REZN-24-18

Rezoning Conditions of Approval

1. **Project Name:** Jamestown Quarry Commercial SIP
2. **Location:** 43.0171, -89.4819
3. **Permit Request No.:** RZ-2573-24
4. **Ordinance No.:** 2024-O-35
5. **Decision Date:** November 19, 2024
6. **Legal Description:** Metes and bounds
7. **Current Zoning Districts:** PDD-GIP
8. **Proposed Zoning Districts:** PDD-SIP

Jamestown Quarry Specific Implementation Plan

SHEET TITLE:
SITE SECTIONS

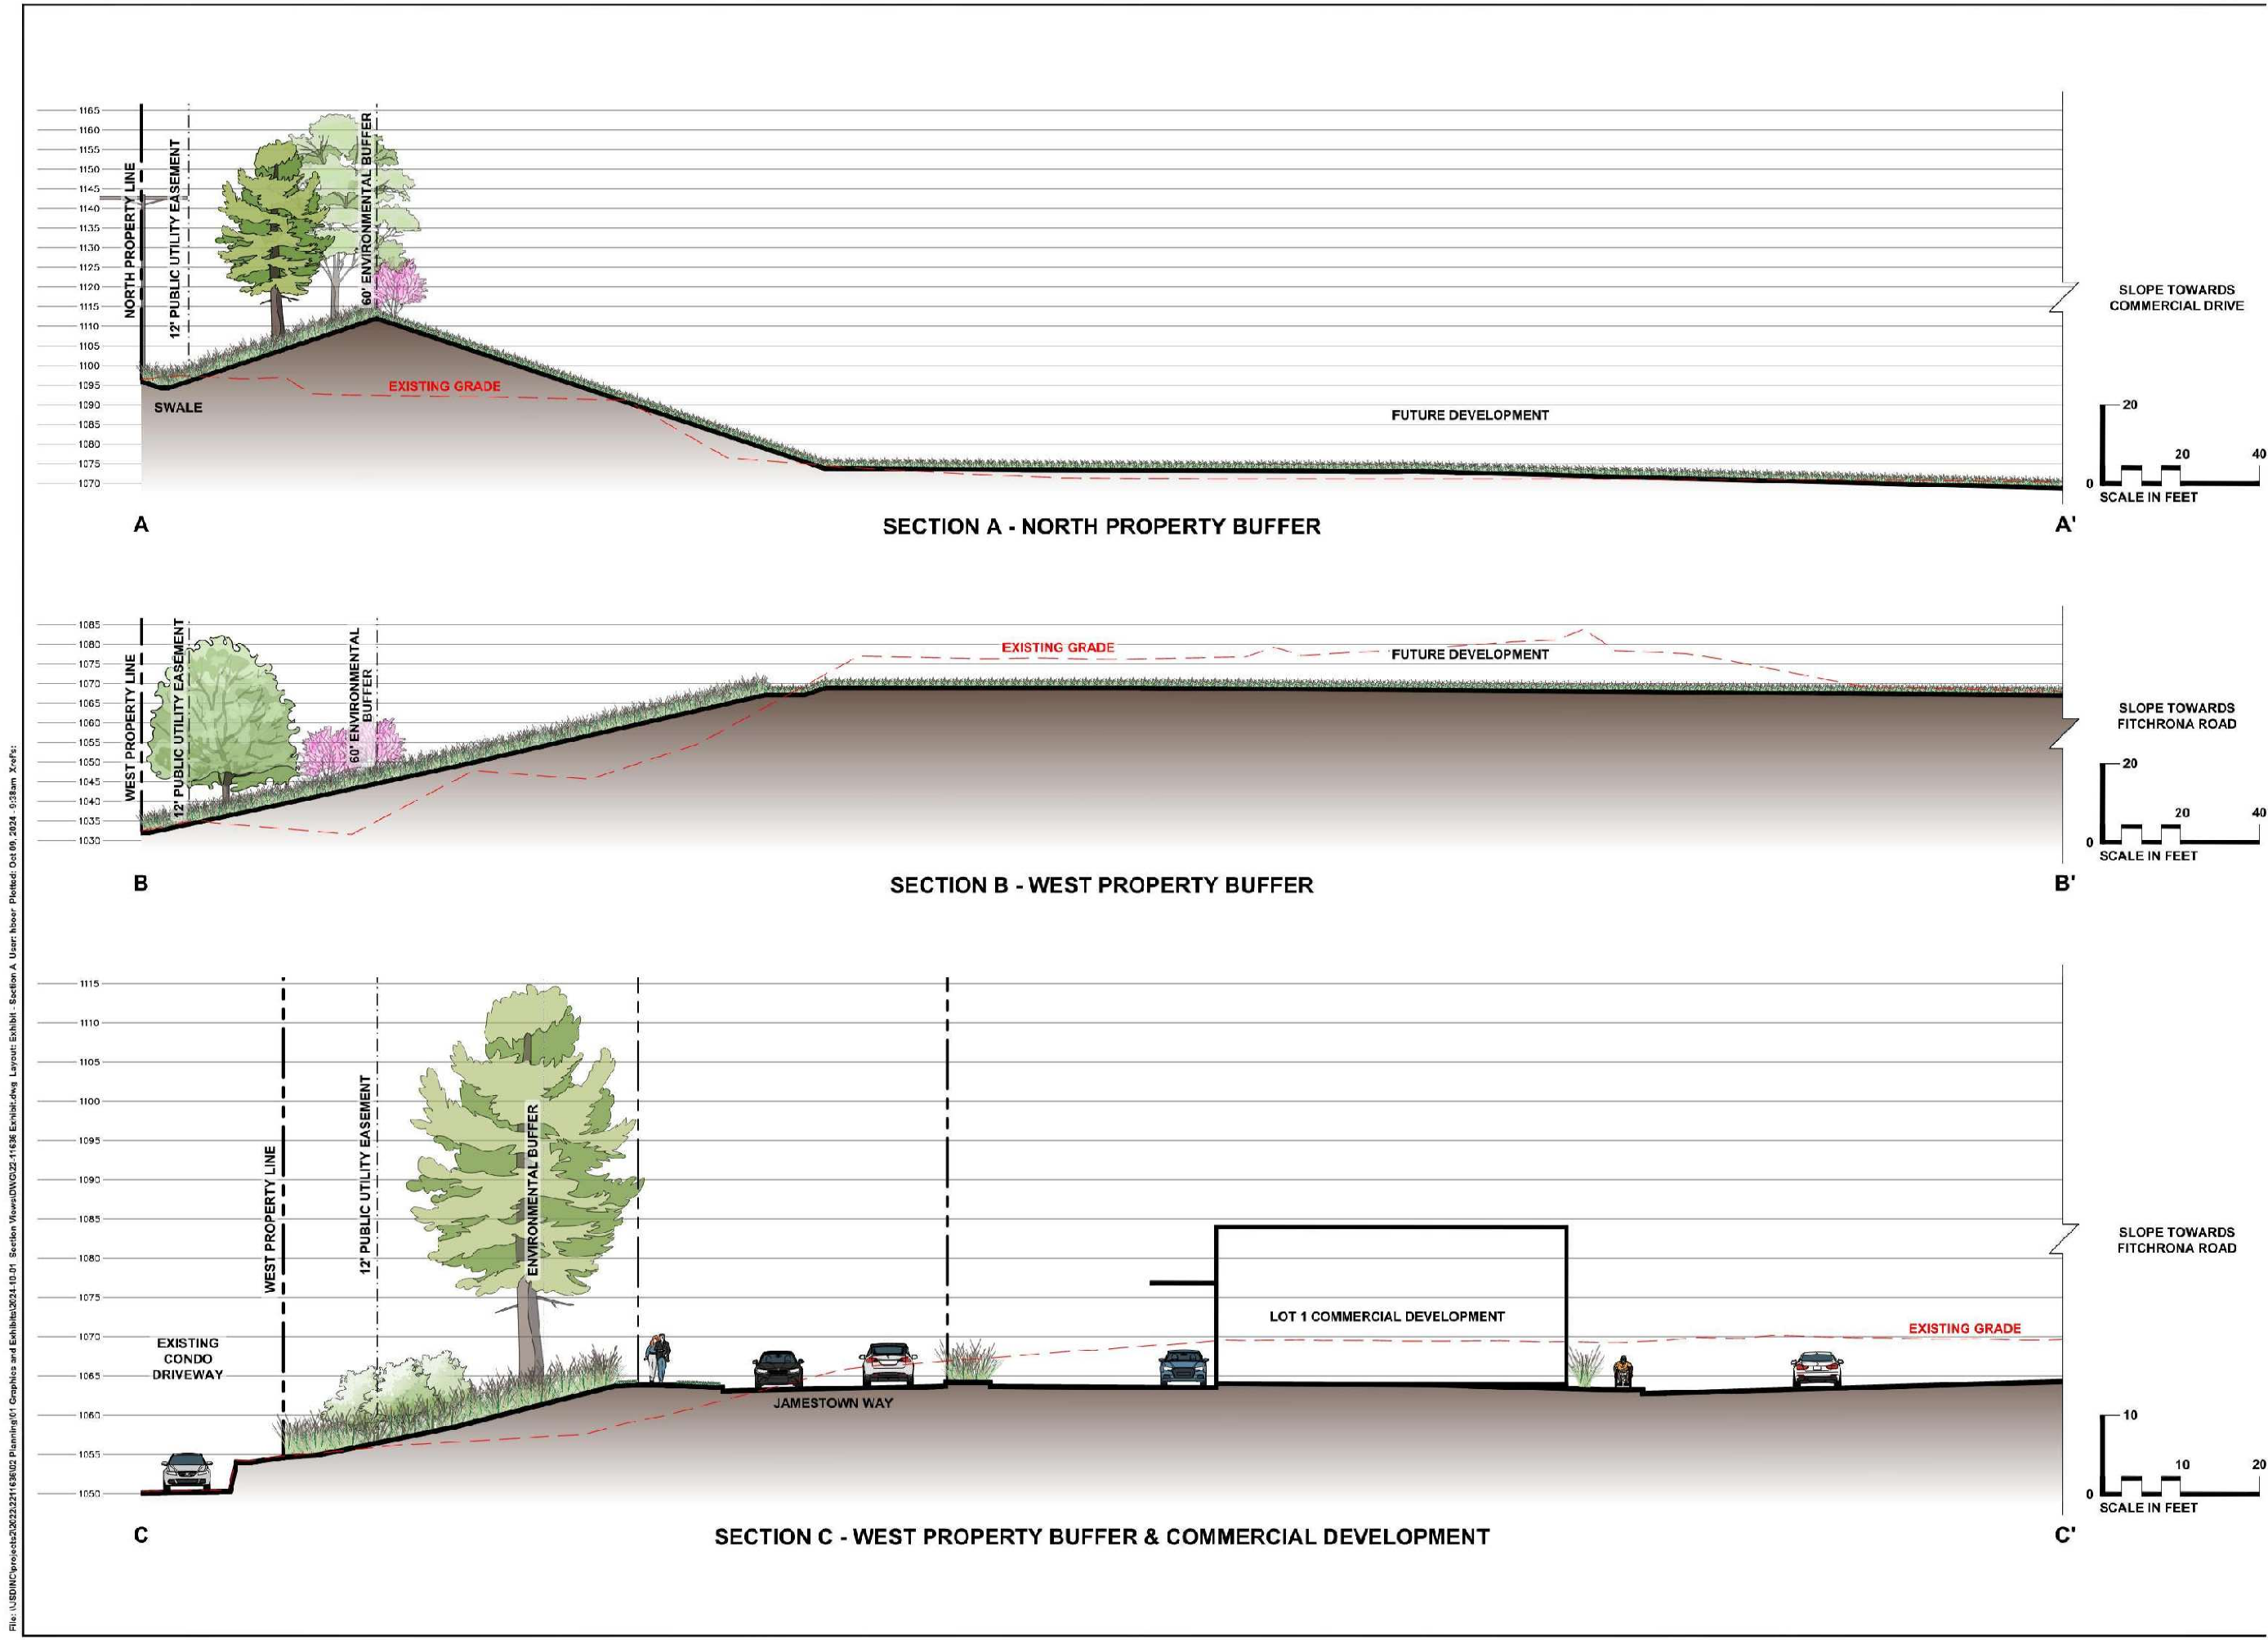
- a. Understood, pending site plan revisions will address this comment further.
21. Landscaping and grading on the outlots:
 - a. The grading plan and cross-sections seem to indicate that runoff from the development will impact the condos. The area is currently heavily vegetated and limited impact on the condos. Clearing and regarding will create issue. How will this be addressed?
